Re application of: : GUDRUN VANDEGINSTE  
Serial No. : 09/543,016  
Filed : April 4, 2000  
For : APPARATUS FOR PROCESSING SIGNALS  
Group No. : 2614  
Examiner : Linus H. Lo

**SUBMISSION OF PROPOSED DRAWING AMENDMENT  
FOR APPROVAL BY EXAMINER (37 C.F.R. §1.121)**

FIG. 1

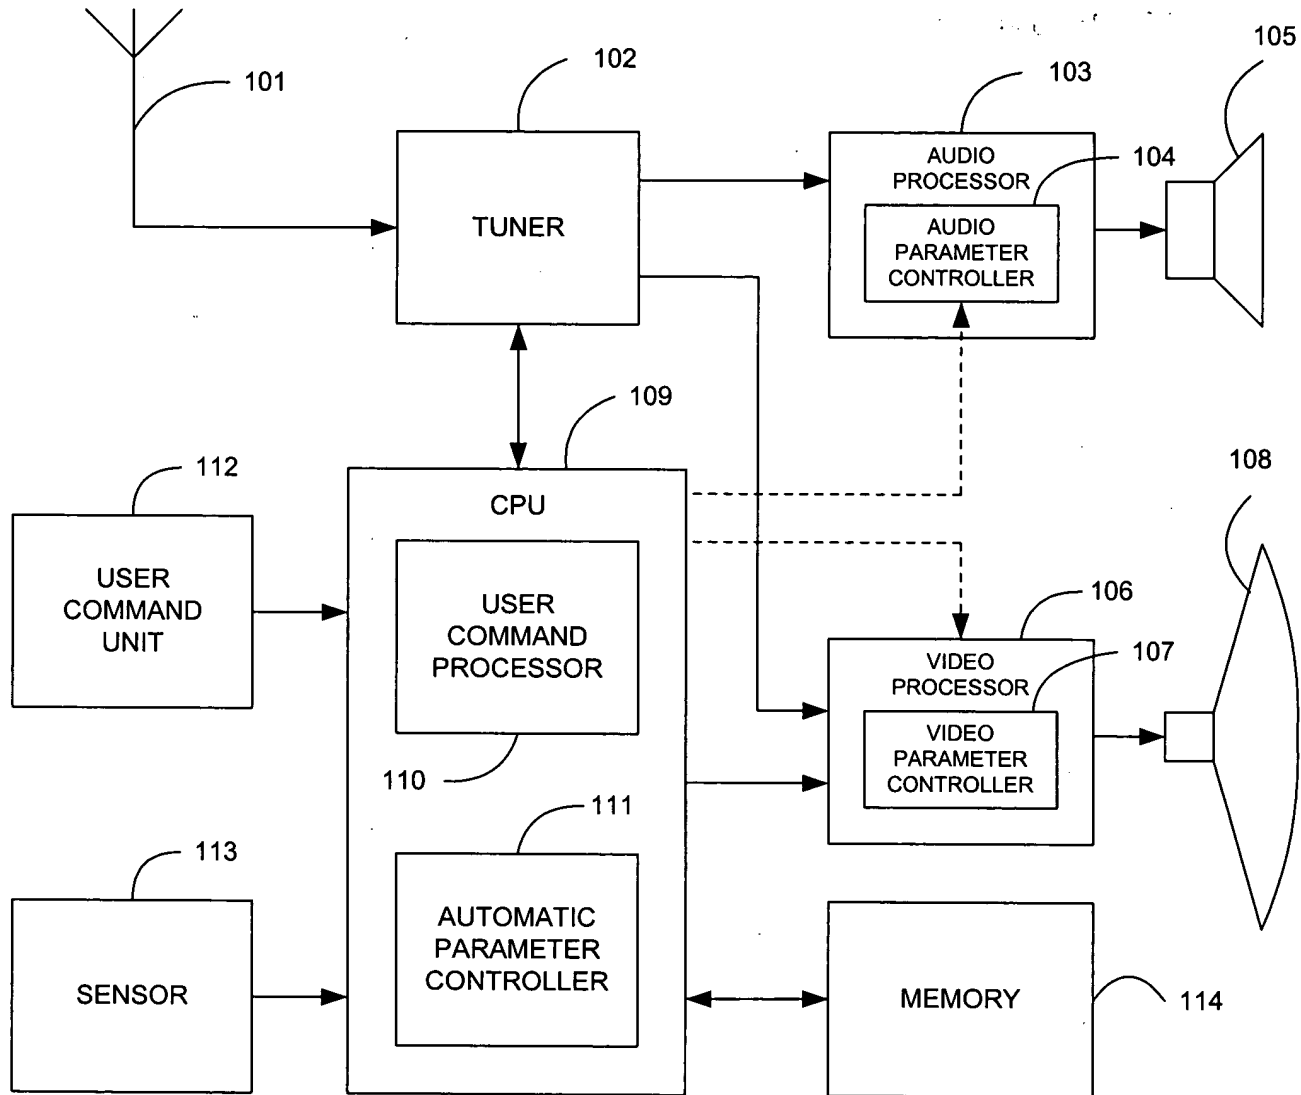
In Section 1 of the October 1, 2002 Office Action the Examiner objected to the original set of informal drawings because the drawings failed to provide suitable descriptive legends to identify the box elements in the drawings. In response, the Applicant has submitted a substitute set of informal drawings with descriptive legends that identify the box elements in the drawings.

Please compare the substitute set of drawings with the original set of informal drawings. The submitted drawings also include a copy of the substitute set of drawings showing in red the proposed changes to the original set of drawings. The approval of the Examiner is requested for the substitute set of drawings.
